NEATH SHRIMP FARM

TRANSPORT STATEMENT – ADDENDUM_V2

FEBRUARY 2024

PLANNING APPLICATION NO: 2/3/23/0845/00
APPLICANT: MR LEE TANNER
LOCATION: THE METAL BOX, MILLAND ROAD INDUSTRIAL
ESTATE, NEATH, SA11 1NJ
PROPOSAL: CONVERSION OF REAR SECTION OF EXISTING
BUILDING TO CREATE A SHRIMP FARM
(AQUACULTURE BUSINESS) INCLUDING
RECONFIGURATION AND CLADDING OF ROOF
TO PROVIDE ADDITIONAL HEIGHT CLEARANCE
TOGETHER WITH ANCILLARY ALTERATIONS
AND DRAINAGE (AMENDED ROOF
ORIENTATION)

DRAWING TITLE
SWEEP PATH ANALYSIS
LARGE CAR

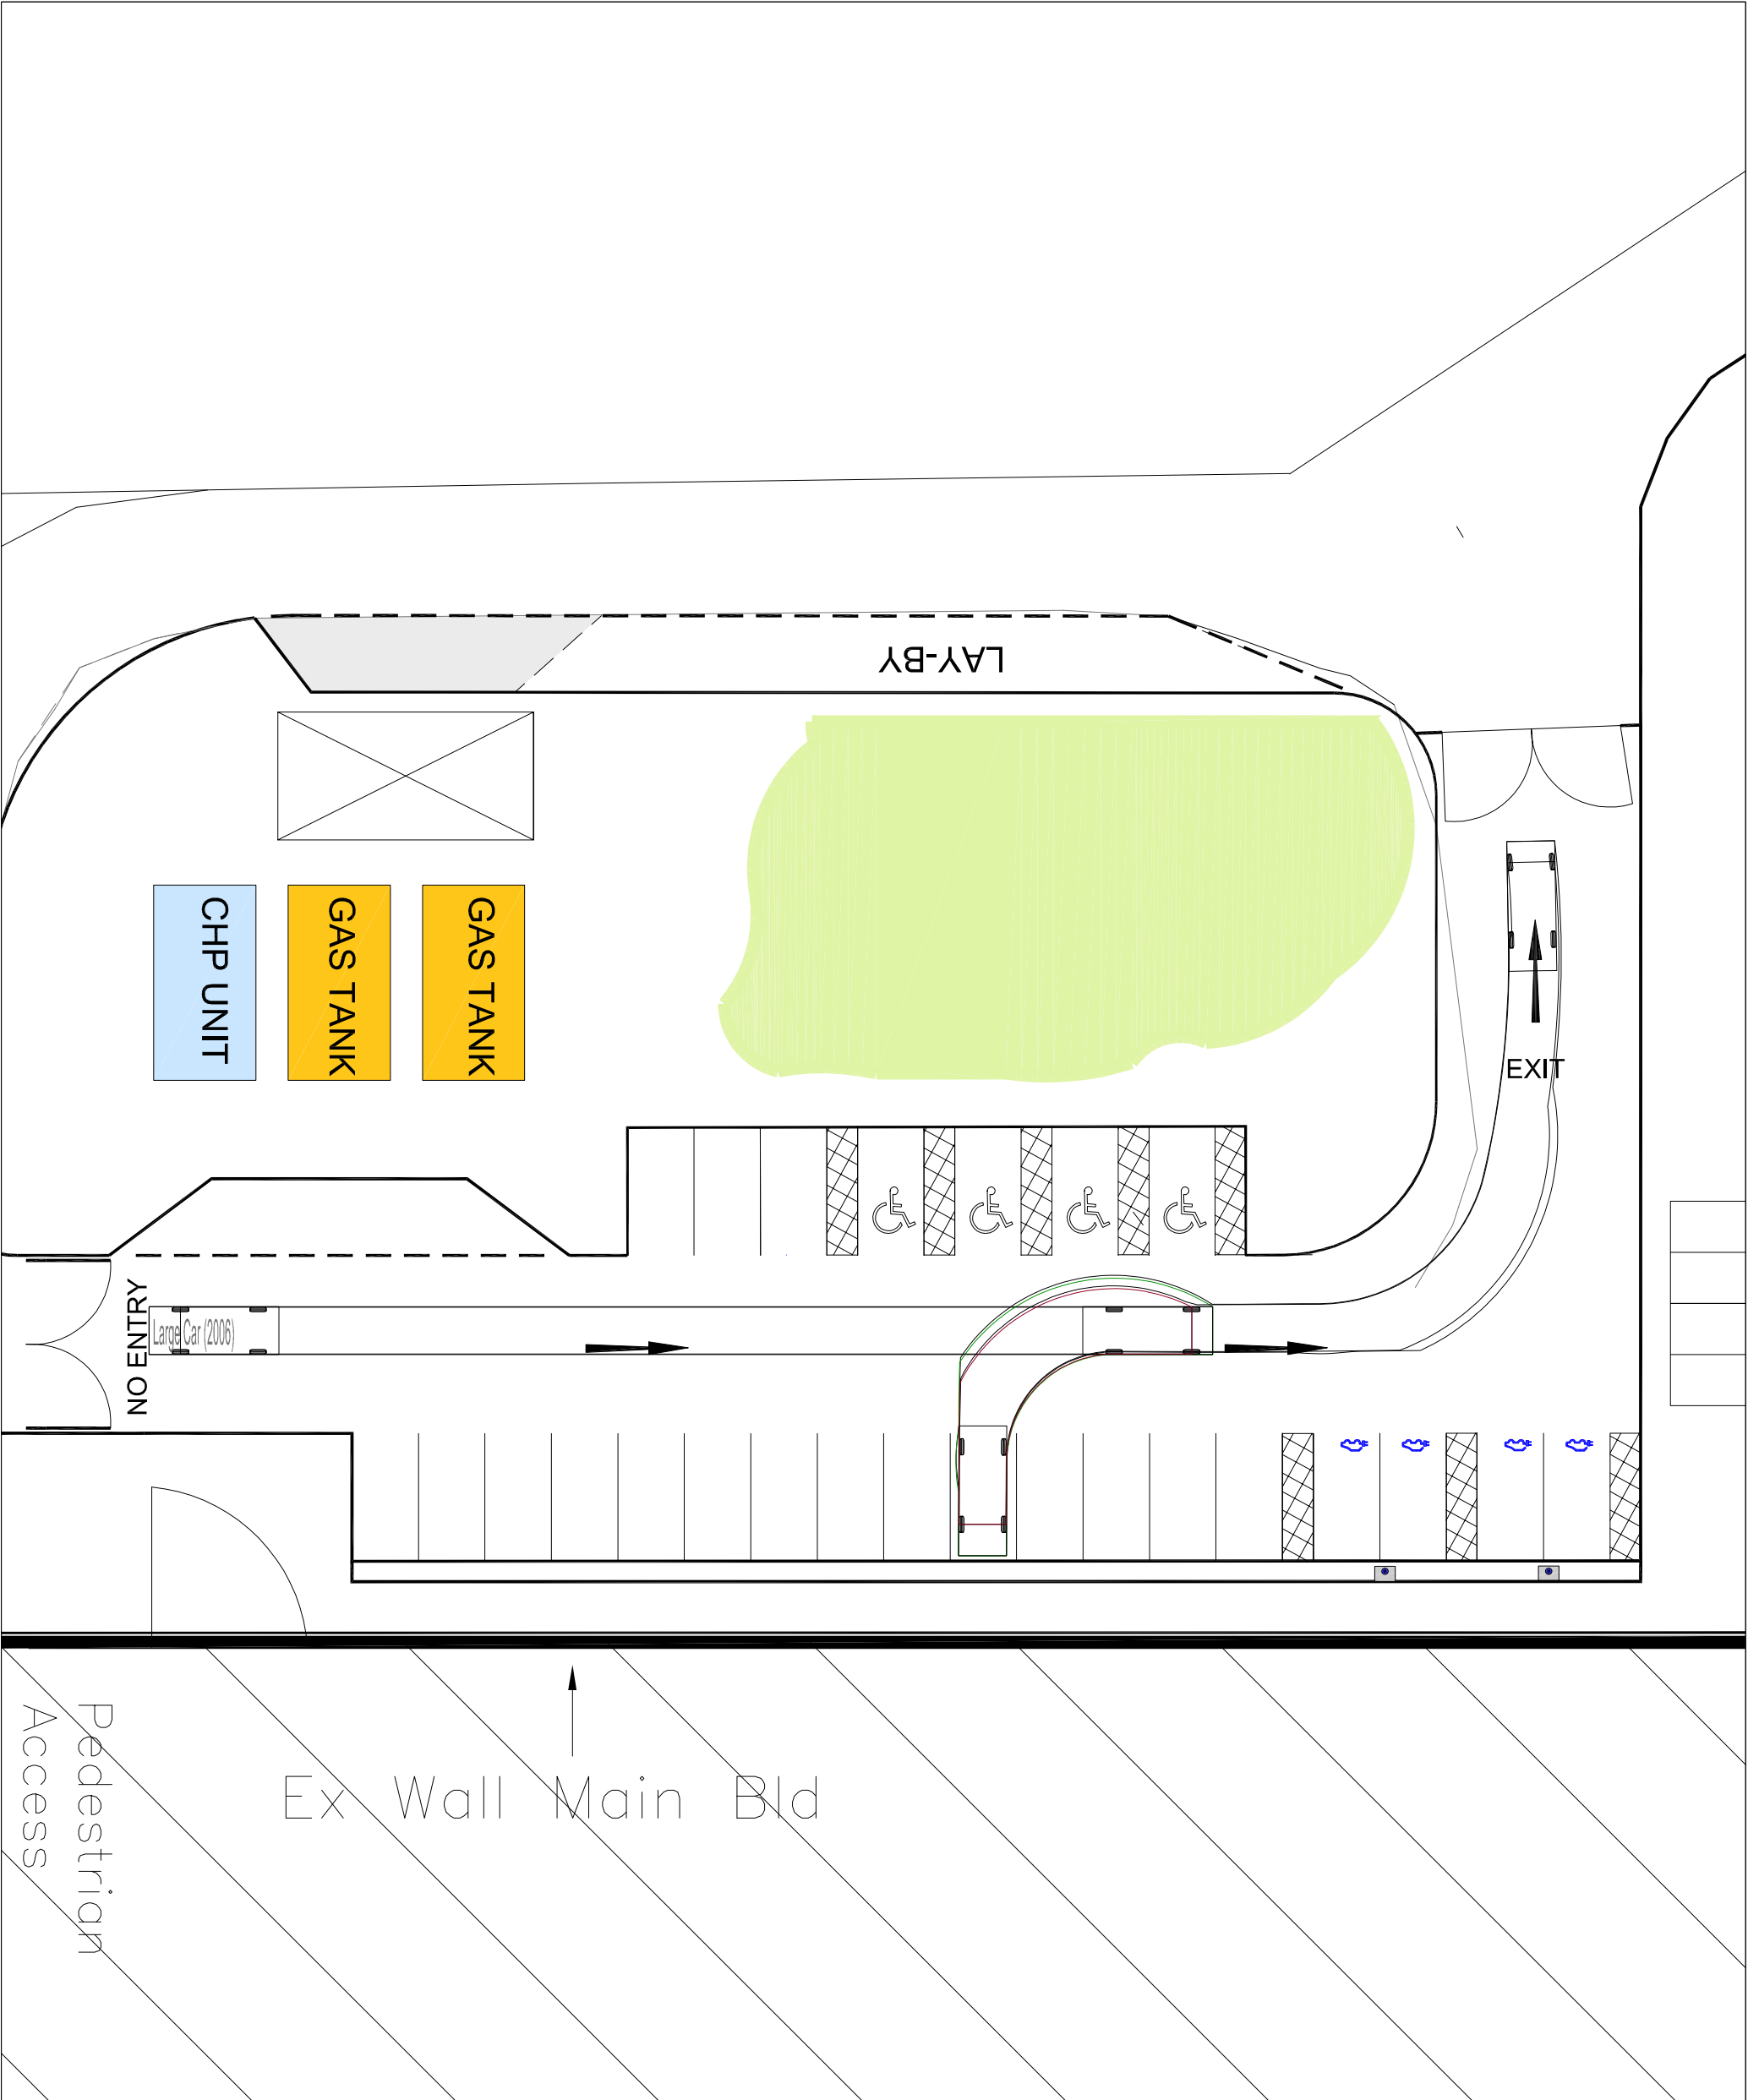
The reversing distance appears to be greater than 60m, this is not acceptable – a turning area should be provided closer to the access. We would not be able to accept that the vehicles would turn inside the facility. A suitable turning area should be provided. The proposed gradient of the ramp should also be provided.

- 2.2.1 Turning area for small vehicles using gate 2 is now provided. See **SK05_RevB** attached as **Appendix B**.
- 2.2.2 Turning for HGV's is now not required and a one-way circulation through the car park with an entry only to the south side provides entry and exit in a forward gear for a 16.5m HGV. See attached **SK04_RevC** attached as **Appendix B**.
- 2.2.3 In this regard, reversing distances reduced to less than 10m for smaller deliveries and no reversing required for HGV's therefore, comment addressed, and no further work considered necessary.
- 2.2.4 **SK02_RevC** and **SK03_RevC** are also attached to demonstrate the swept paths of a large car and a 7.5T Box Van.
